PROJECT:  
URA KWUN TONG TOWN CENTRE REDEVELOPMENT (AREA 2 & 3) AT NKIL 6514 KWUN TONG, KOWLOON

TITLE:  
AC PLATFORM GRILLE DETAILS (PRECAST FACADE)

TENDER ADDENDUM NO. 1

1 TYPICAL DETAILS FOR ALUM. GRILLE AT A/C PLATFORM (PRECAST FACADE)

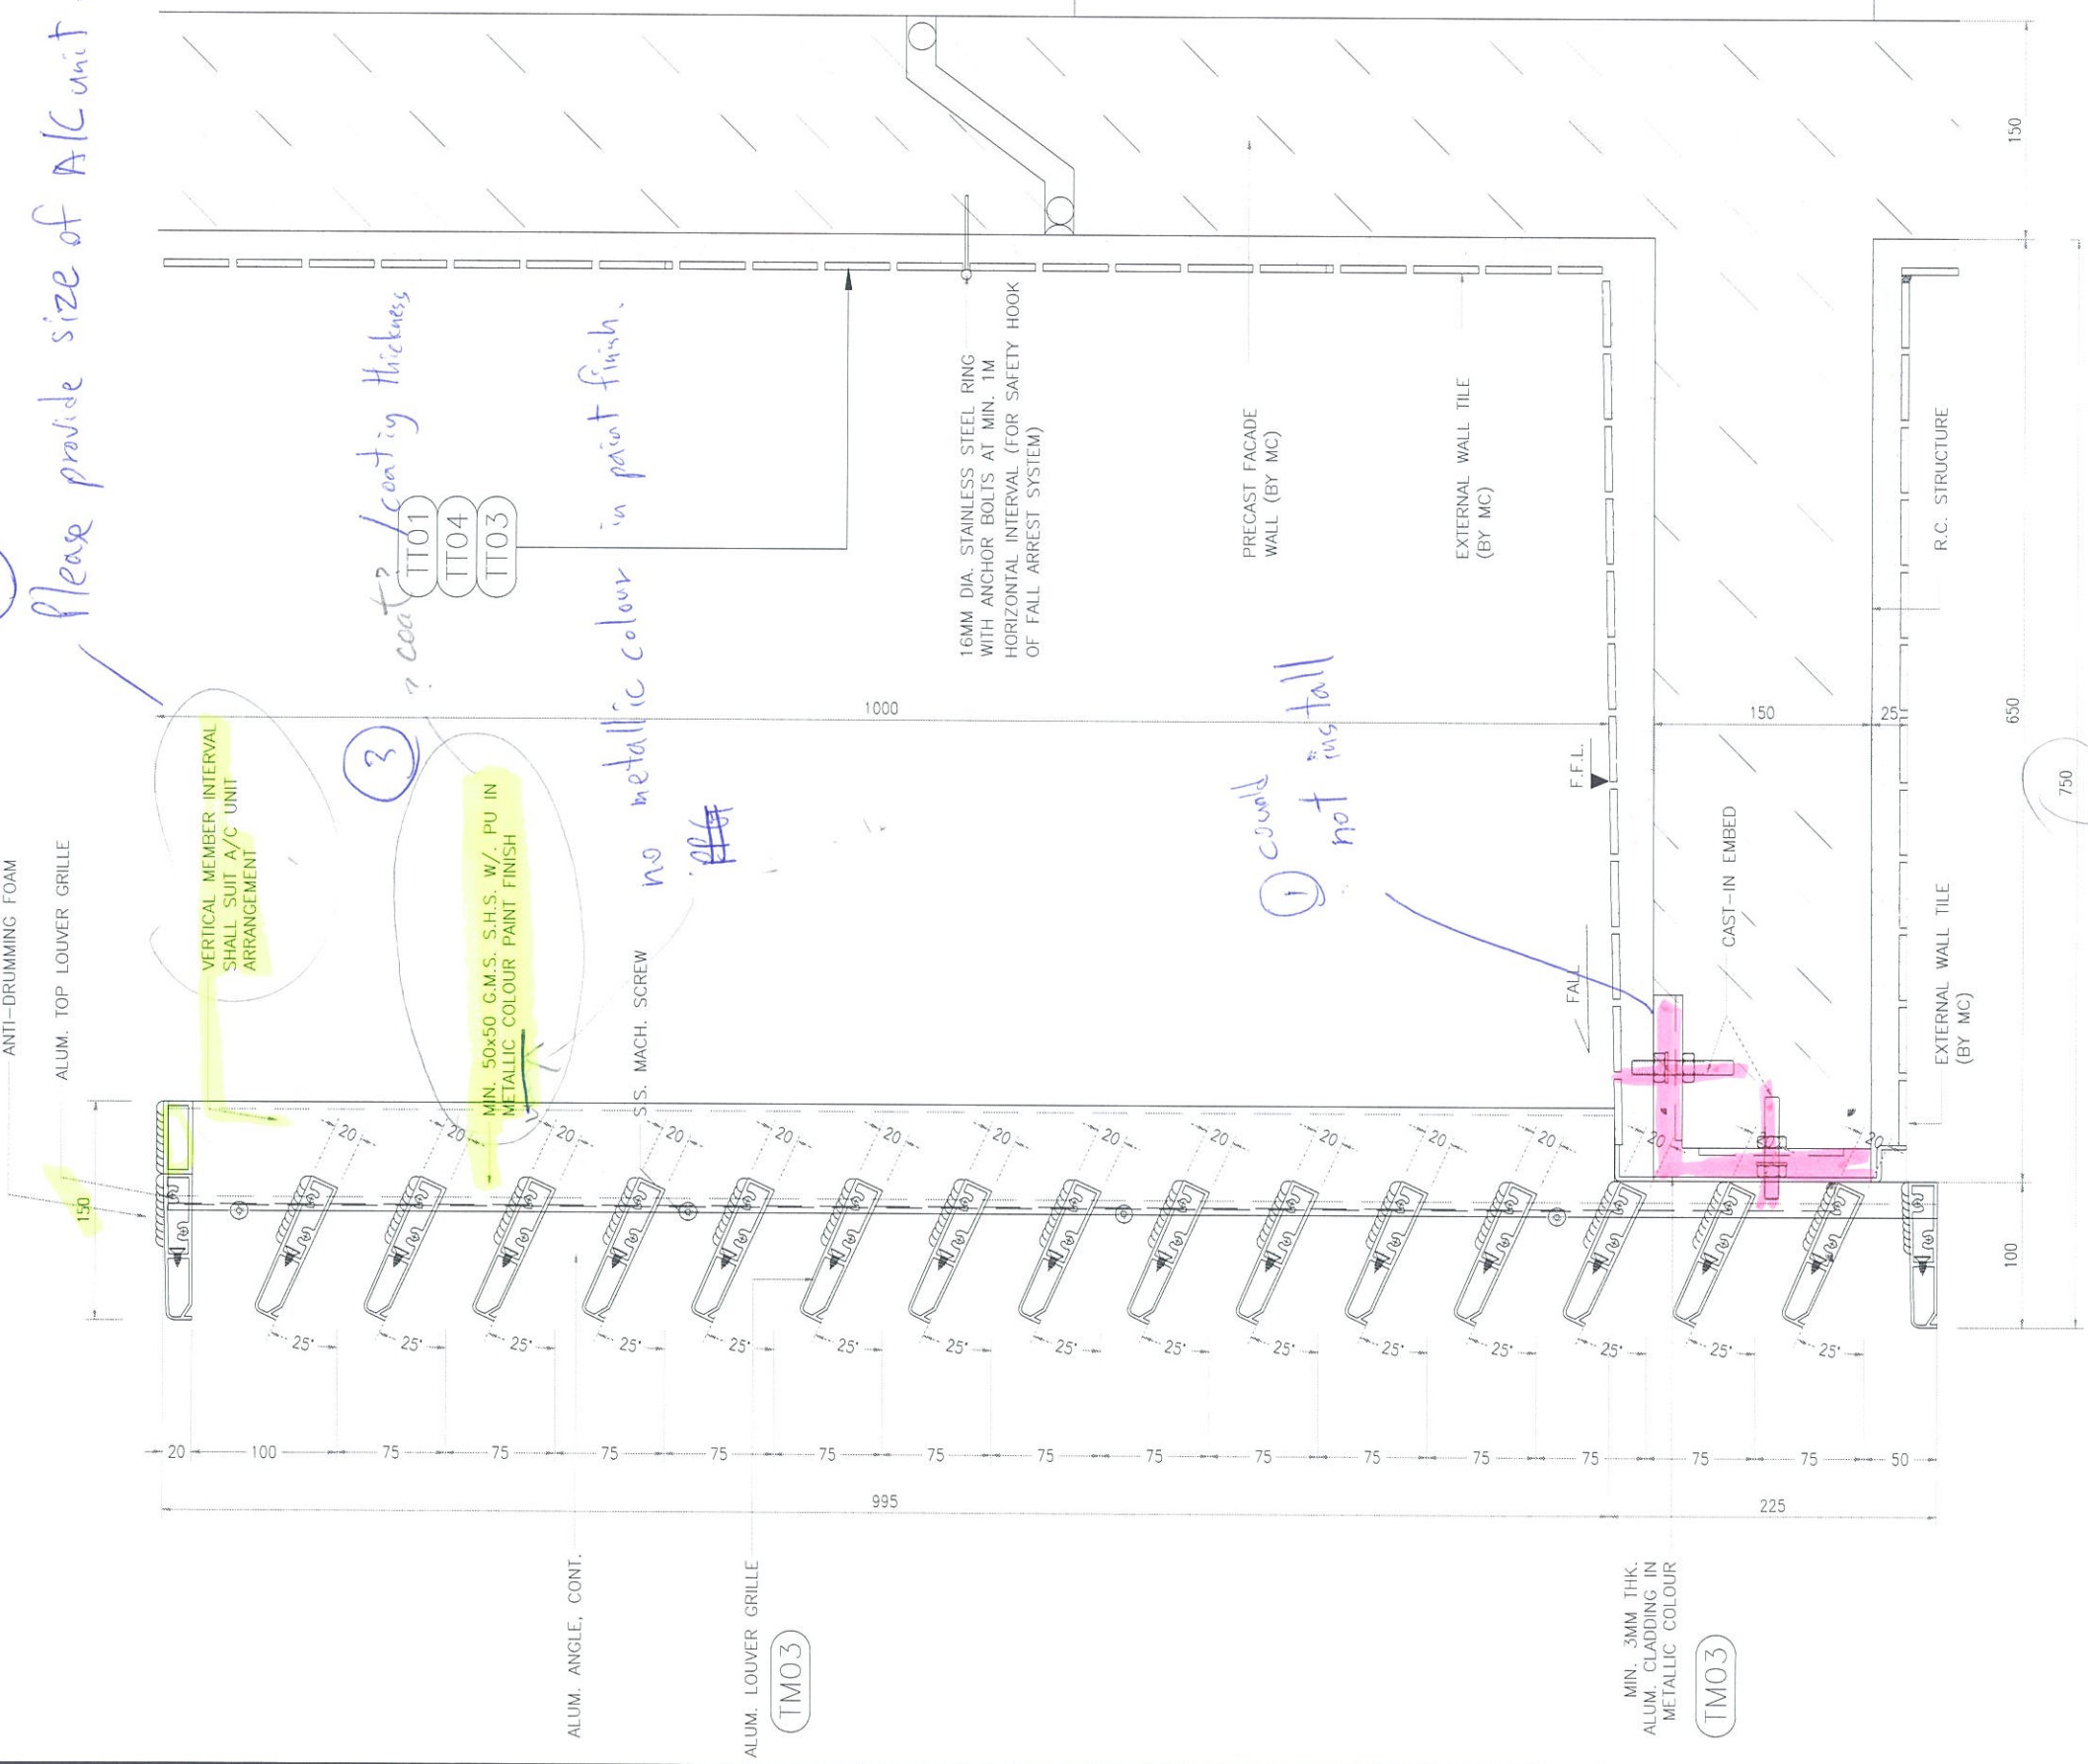
2 Please provide size of A/C unit.

3 coating thickness  
no metallic colour in paint finish.

1 could not install
